File No: R/2015/8/C  
Our Ref: 2019/306704

**Crown Sydney Hotel Resort, Barangaroo South - SSD 6957 MOD 1**

**Figure 1** Building setbacks from the water's edge and location of proposed wind breaks in red (excerpt from drawing number 00915-P-0103-TP *Site Plan – Ground floor* prepared by Wilkinson Eyre)

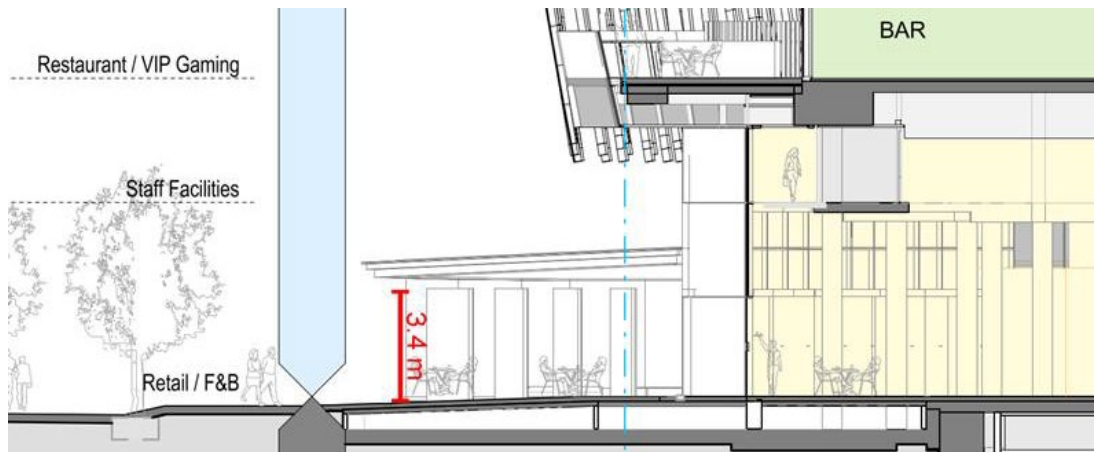
The proposed wind mitigation efforts on the ground floor are considered to have a detrimental impact on the public domain with the introduction of full height blades to the outdoor bar terrace.

The enclosure and further privatisation of an outdoor terrace as shown in Figures 1 and 2 below encroaches on the suggested 25m setback of the building at the ground floor and reduces the width of the open space from the water's edge to only 16.7m. The introduction of 3m high wind blades at the north-western bar terrace proves to enclose an approved outdoor space with little improvement to outdoor pedestrian comfort within the public domain, failing to adequately address wind impacts of the development on the already reduced public promenade.
